LCI - CR 1332/Encore Parkway Improvements

SUBJECT APPROVED REVISED CONCEPT REPORT

DEPARTMENT OF TRANSPORTATION
STATE OF GEORGIA
REVISED PROJECT CONCEPT REPORT

Project Type: <u>Enhancement</u>	P.I. Number: <u>0010241</u>
GDOT District: <u>7</u>	County: <u>Fulton</u>
Federal Route Number: <u>N/A</u>	State Route Number: <u>N/A</u>
Project Number: <u>N/A</u>

BRIDGE NO. 1
GEORGIA
DEPARTMENT OF TRANSPORTATION
ENGINEERING DIVISION-OFFICE OF BRIDGES AND STRUCTURES
CONCEPT LAYOUT
ENCORE PARKWAY OVER SR 400
FULTON COUNTY XXXXX-000X-001XXXI
SCALE: NO SCALE
DECEMBER 2000

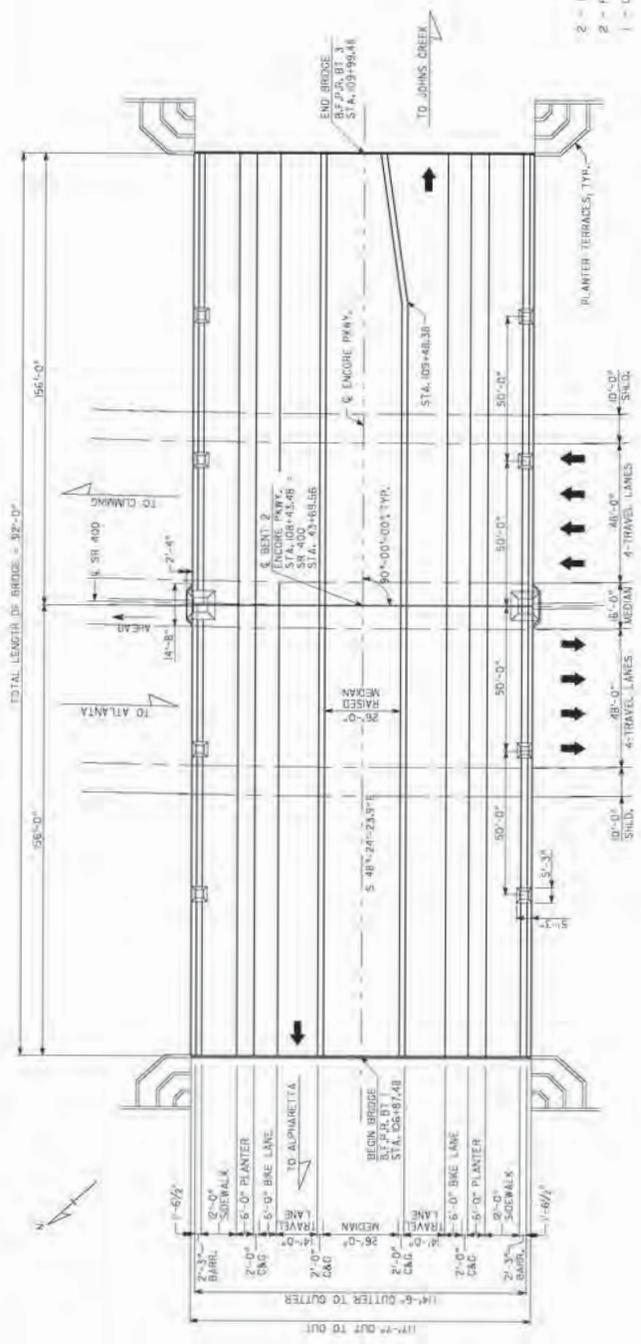
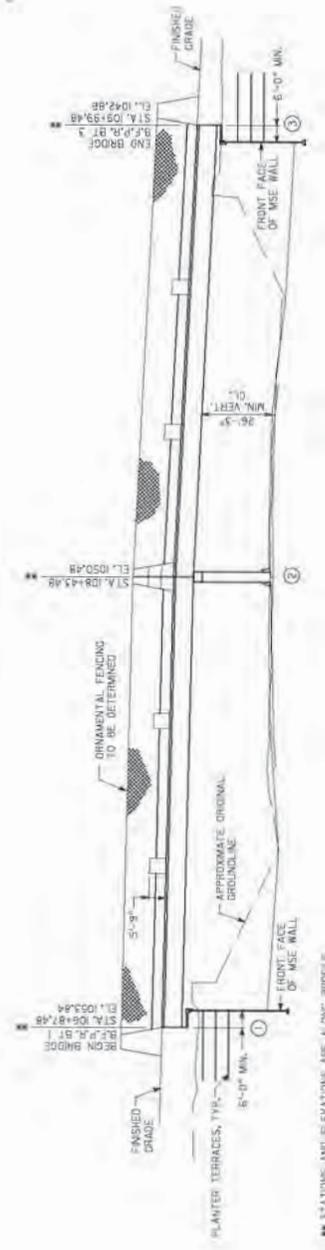
Idea A-14: Reduce the length of the Encore Parkway Bridge by eliminating the 50-foot end spans.

I am in agreement with the responses provided by the consultant, ARCADIS. Alternative A 14 proposes to eliminate the end spans by moving the proposed end abutment walls to the approximate location of piers 2 and 4 (from the original conceptual drawings). This project is in the concept phase and preliminaries have not been submitted for our review. We generally do not recommend using end abutments unless the project is constrained by Right of Way or due to staging. I accept the proposed savings for this alternative. However, should we recommend a change once the preliminary layouts are submitted for our review, then the Project Manager would need to request a reversal from Engineering Services.

ARCADIS Response – Will implement. Further coordination with the SR 400 Managed Lanes project and MARTA is required. The overall bridge length and span arrangements will be reduced as much as possible without precluding those future projects.
